Sams Attire Ltd (Extension 2)

Bhuiyan Tower, Plot No. 10, Ashulia Jamgora, Savar, Dhaka.

3 November 2024

2. Observations:

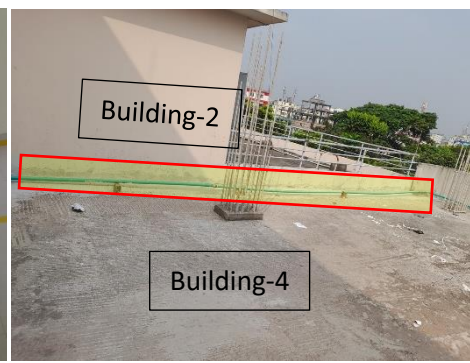
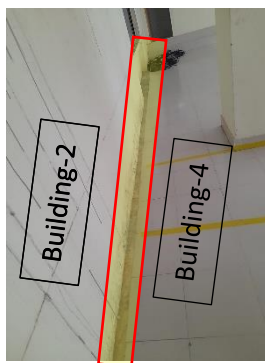
In general note of the drawing, design concrete strength has been considered 4500psi for the column, foundation, and grade-beam and 4000psi have been considered for the slab & beam. But in the EA report and FEA model 4000psi have been considered for all the structural members.

During inspection, Total 5 sets of cylinder test report (3 sets from columns, 1 set from foundation and 1 sets from slab) were available which does not satisfy the frequency of cylinder tests as per BNBC-2020. The deviation from the requirement, the building engineer is required to take concrete core samples from RC members to verify the in situ concrete strength. Revise the design documents based on in-situ material strength.

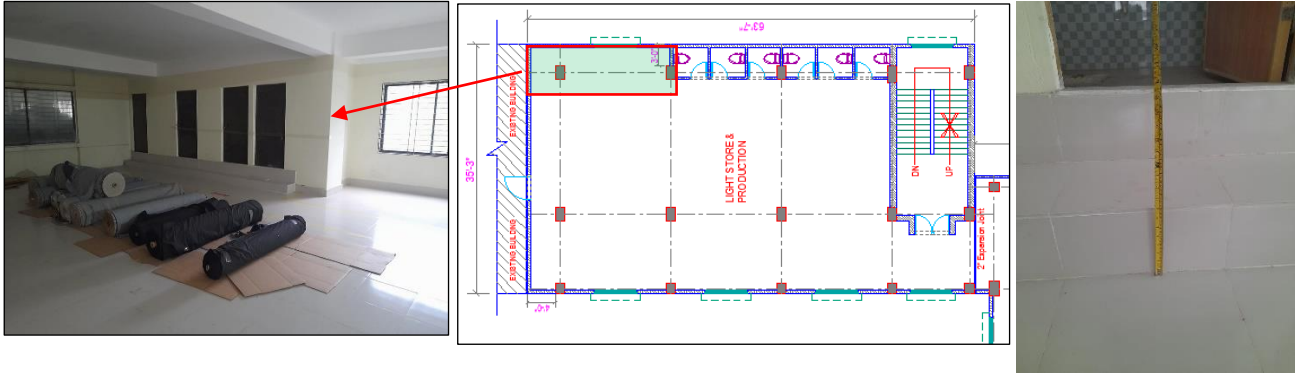
In the design document, the response reduction factor has been considered $R=5$ that is Intermediate reinforced concrete moment frames. But in the design report, supporting calculations have not been provided in detail.

Observation-2: Mismatch in the provided drawing. (Building-4)

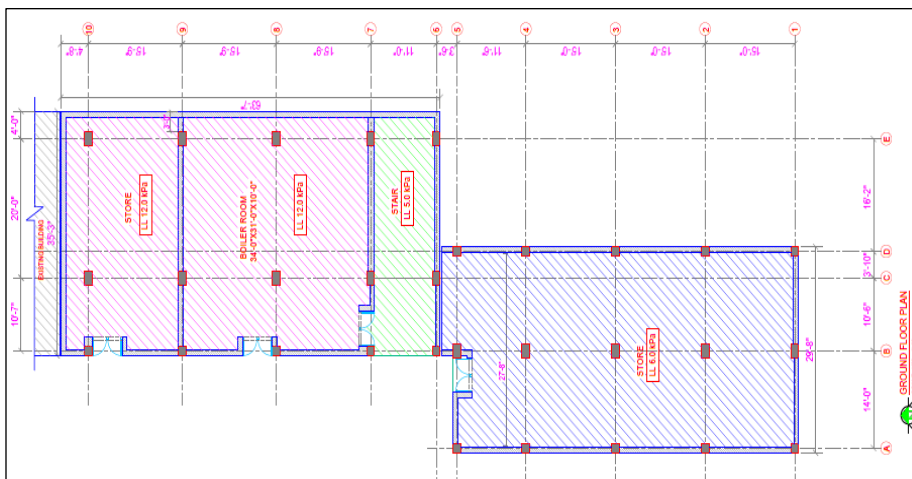
Description: During the inspection, the mismatch was found between the provided drawing and the site condition. The toilet zone position was not found as per the drawing. The toilet zone was found as marked location in the layout. Also, approximately 350mm build-up was found in the toilet zone.

The is a lightweight steel tin shed over the stair top. The drawing was not available for the shed in the provided drawing,
The building engineer is required to survey the whole structure and prepare accurate as-built drawings.
